**Committee of Experts on the Transport of Dangerous Goods
and on the Globally Harmonized System of Classification
and Labelling of Chemicals**

**Issues relating to the Globally Harmonized System
of Classification and Labelling of Chemicals: Use
of the Manual of Tests and Criteria in the context
of the GHS**

**Revision of the Manual of Tests and Criteria:
Appendices**

**Transmitted by the Chairman of the Working Group on Explosives on
behalf of the Working Group**

Figure A7.9: SUPPORT STAND

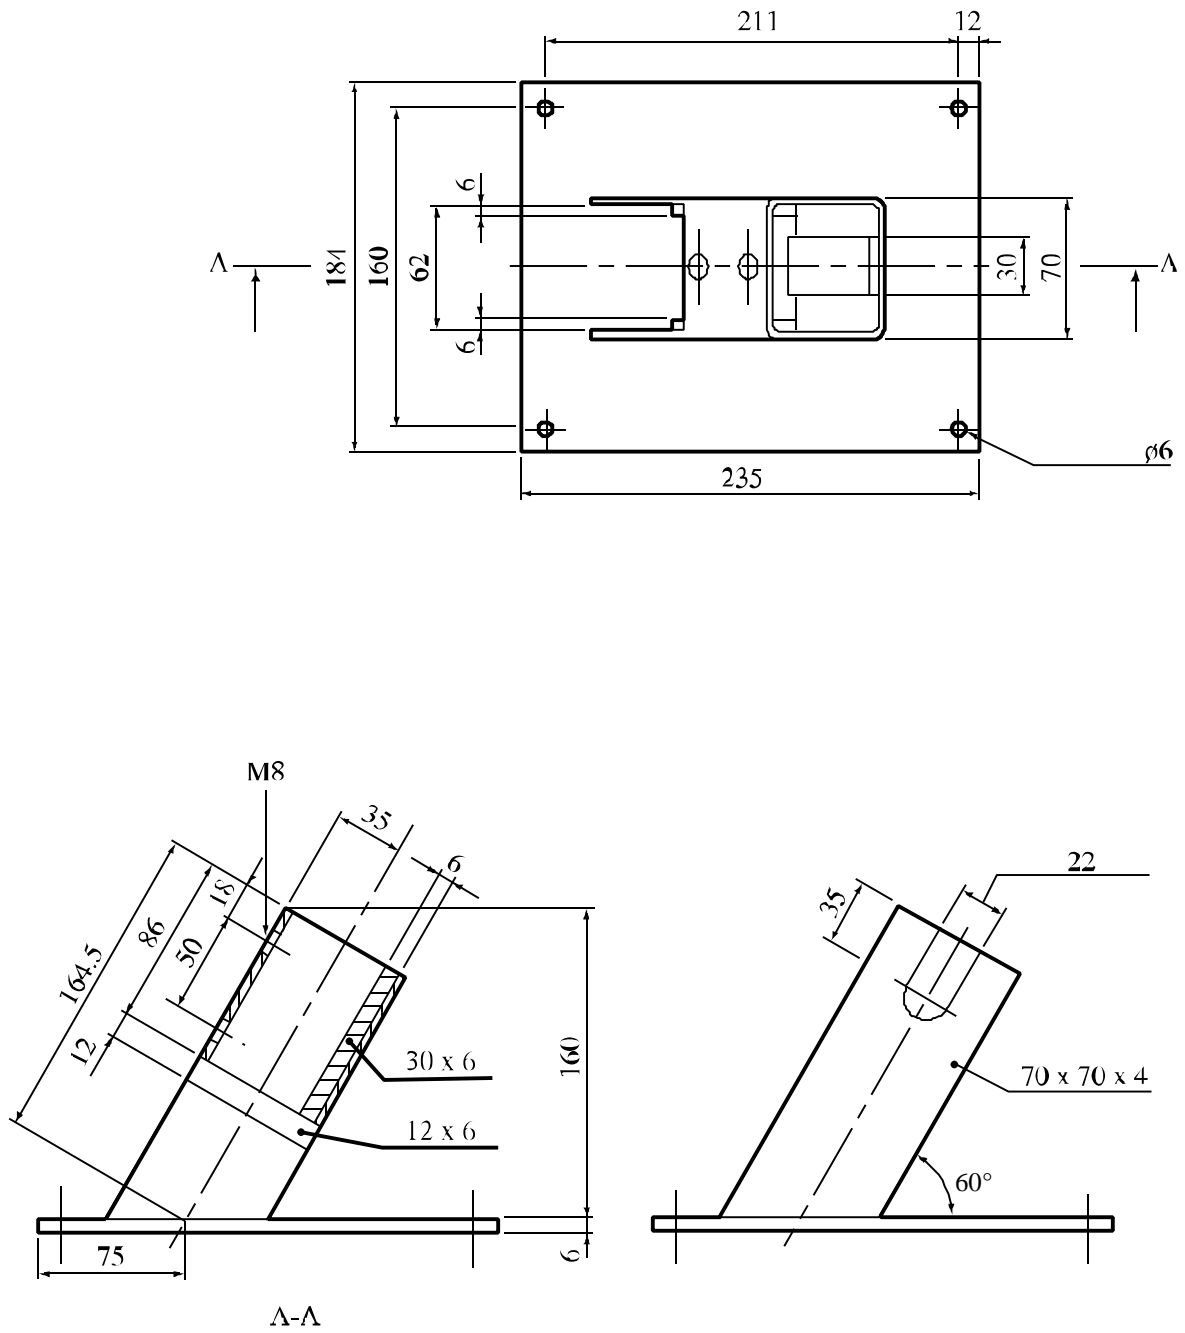
2.3 A support stand (Figure A7.89) holds the assembly in the correct attitude during use. This comprises a mild steel base plate measuring 235 mm × 184 mm × 6 mm and a 185 mm length of square hollow section (S.H.S.) 70 × 70 × 4 mm. A section is cut from each of two opposite sides at one end of the length of S.H.S. so that a structure having two flat sided legs surmounted by an 86 mm length of intact box section results. The ends of these flat sides are cut to an angle of 60° to the horizontal and welded to the base plate.

Note by the secretariat: Correction to be included in a forthcoming corrigendum to the 6th revised edition.
